SUBJECT: AMENDMENT OF SOURCE MATERIAL LICENSE SUA-442 FOR ALTERNATE CONCENTRATION LIMITS, PATHFINDER MINES CORPORATION, SHIRLEY BASIN SITE, CARBON COUNTY, WYOMING, AMENDMENT 57 (TAC LU0095)

TECHNICAL EVALUATION REPORT
ALTERNATIVE CONCENTRATION LIMITS APPLICATION
PATHFINDER MINES CORPORATION
SHIRLEY BASIN SITE, CARBON COUNTY, WYOMING

Docket No.: 40-6622 **License No.:** SUA-442

FIGURE 1. LOCATION OF SHIRLEY BASIN TAILINGS

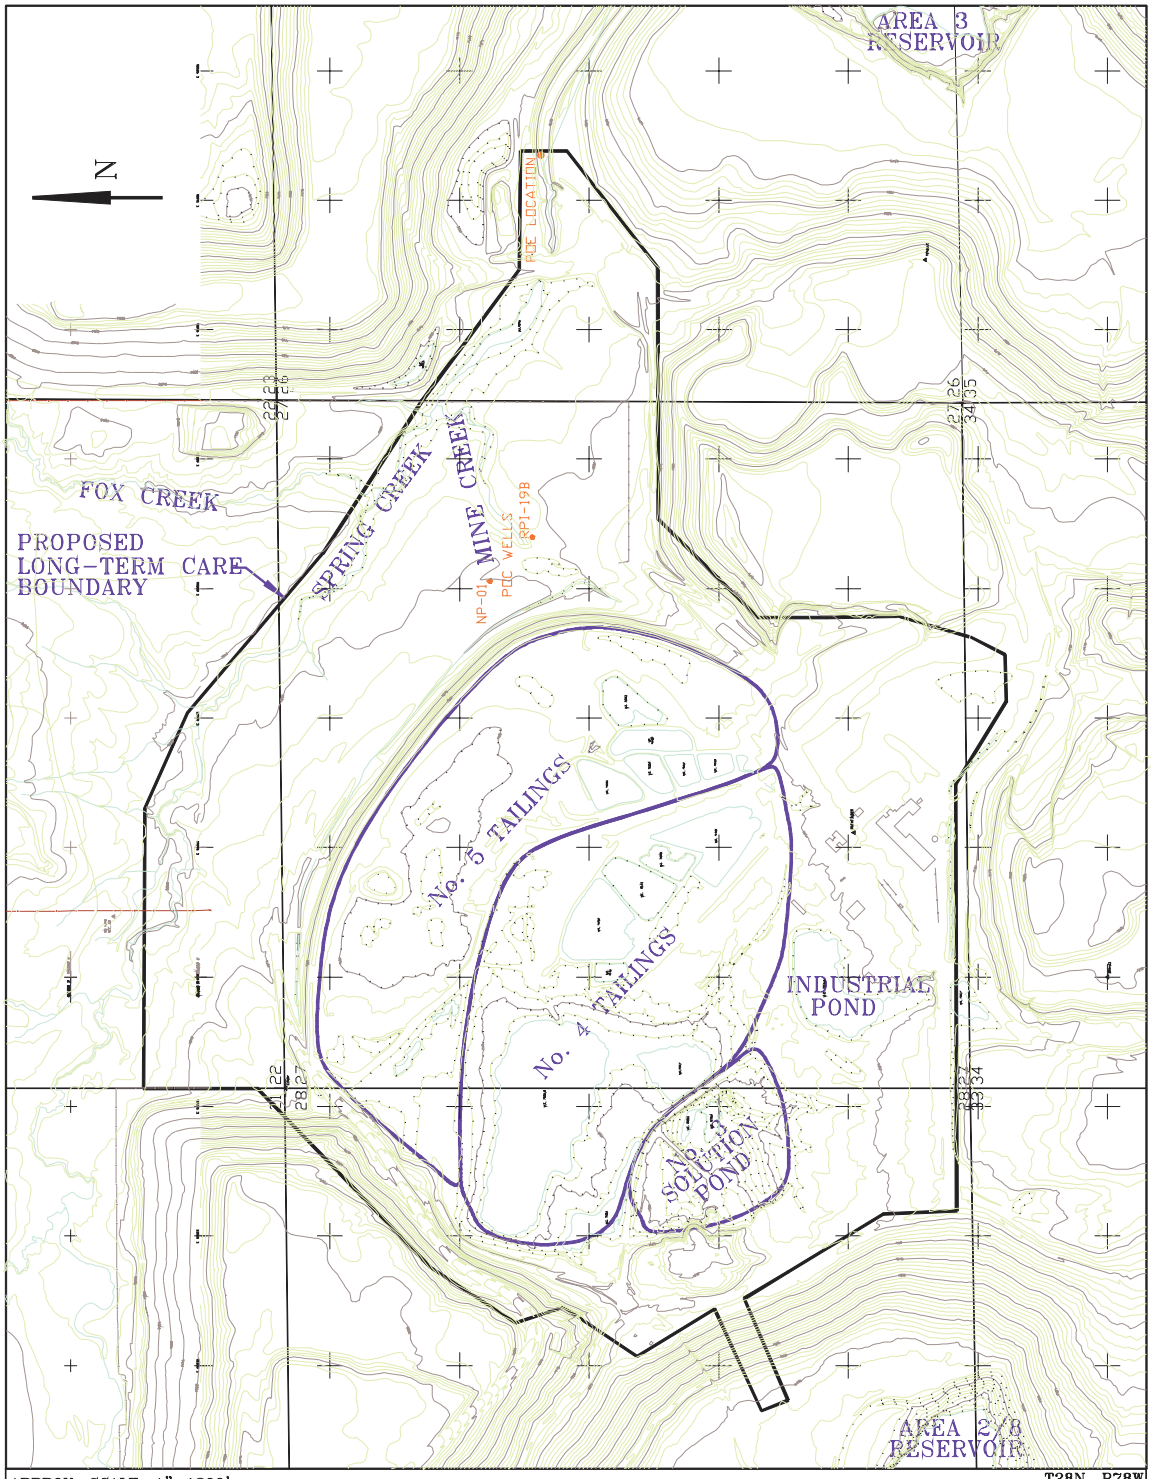
Seepage from the tailings has impacted portions of the Surficial aquifer at the Site; consequently, this is the aquifer for which site standards and corrective actions were developed. Ground water in the Surficial aquifer flows east of the tailings and discharges to Spring Creek. Most of the ground water discharging to Spring Creek is conveyed through more permeable materials in the Mine Creek area. The Surficial aquifer is of limited extent, bounded by the reclaimed Area 2/8 pit on the west side of the tailings and by Spring Creek on the east side (see Figure 1).

FIGURE 2
GROUND-WATER COMPLIANCE MONITORING NETWORK

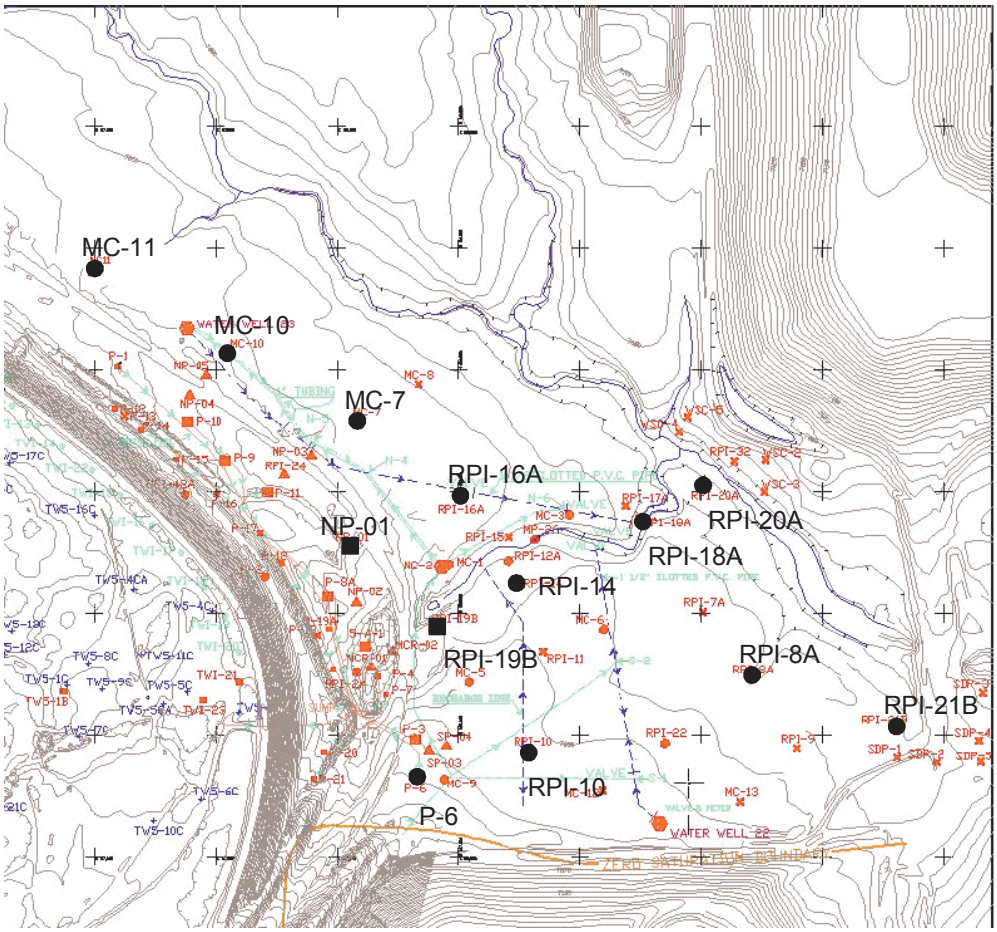
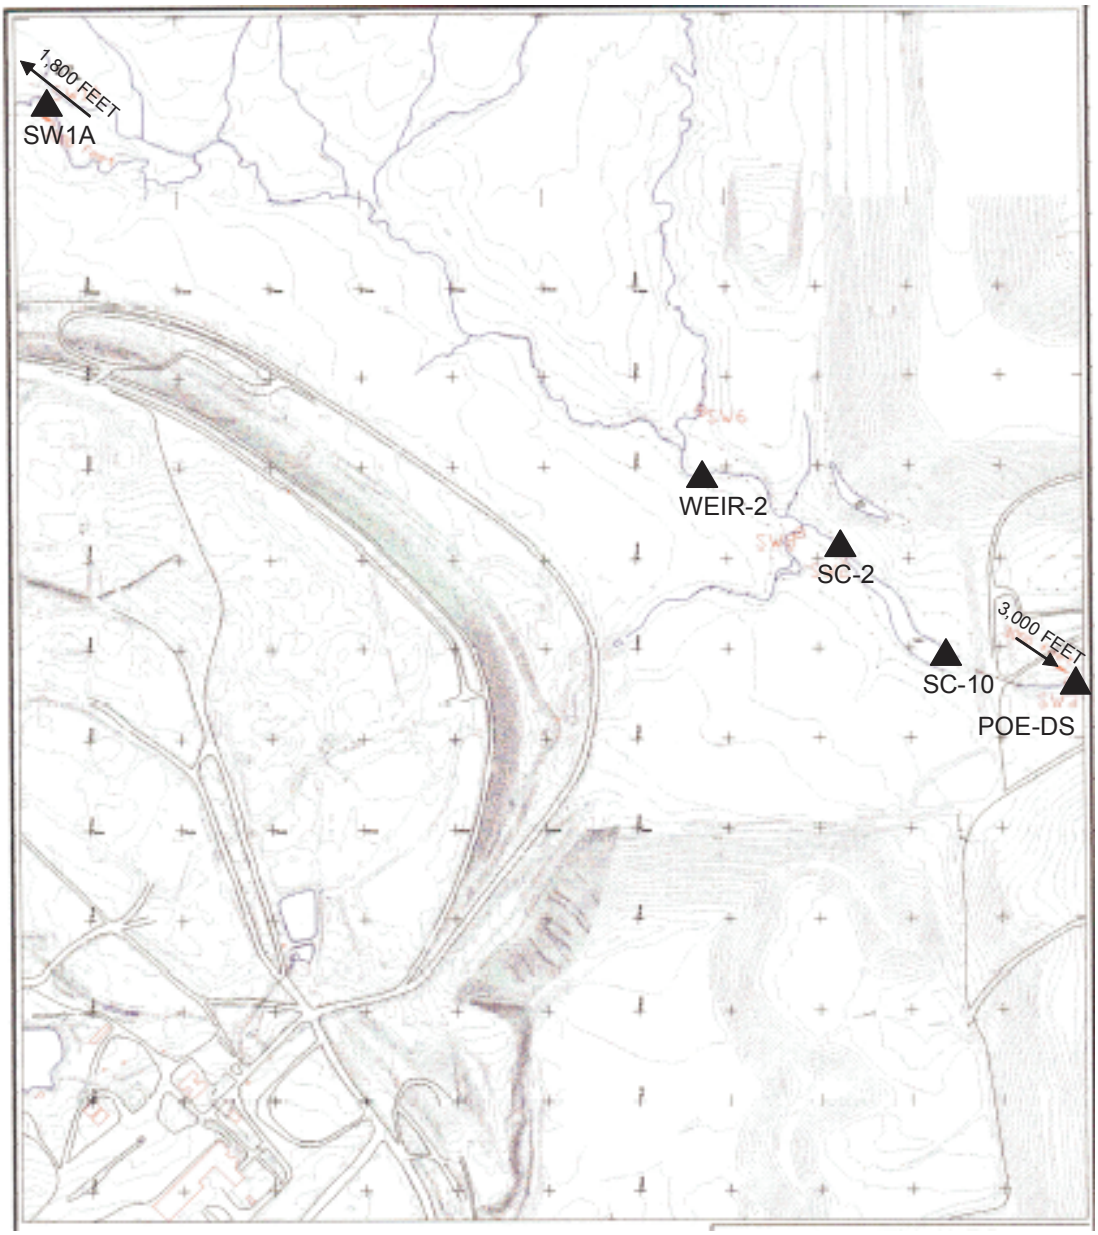
Considering model uncertainty, to assure protection of human health and the environment, a ground-water monitoring program will be continued. For the first 1.5 years after corrective action system deactivation, bi-monthly sampling will occur at the two POC wells (NP01 and RPI-19B); wells P-6, MC-7, RPI-8A, MC-10, RPI-10, MC-11, MC-14 (background), RPI-14, RPI-16A, RPI-

18A, RPI-20A, RPI-21B; and the following five locations in Spring Creek: SW1A (background), SC-2 (POE), WEIR-2, SC-10 (POE), and POE-DS (downstream). After 1.5 years, PMC will sample all of the above ground-water and surface water locations quarterly. These wells and stream locations are spaced to adequately monitor migration of the ground-water contamination over time. Furthermore, if NRC staff determines that an exceedance has occurred, the sampling frequency will be increased to monthly until three monthly samples indicate that the exceedance has abated either naturally or through additional corrective actions. Figures 2 and 3 present the ground-water and surface water monitoring networks.

A. Sample point of compliance (POC) monitoring wells NP01 and RPI-19B; wells P-6, MC-7, RPI-8A, MC-10, RPI-10, MC-11, MC-14 (background), RPI-14, RPI-16A, RPI-18A, RPI-20A, RPI-21B; and five locations in Spring Creek: SW-1A (background), SC-2 (POE), WEIR-2, SC-10 (POE), and POE-DS (downstream) at the following frequencies and parameters:
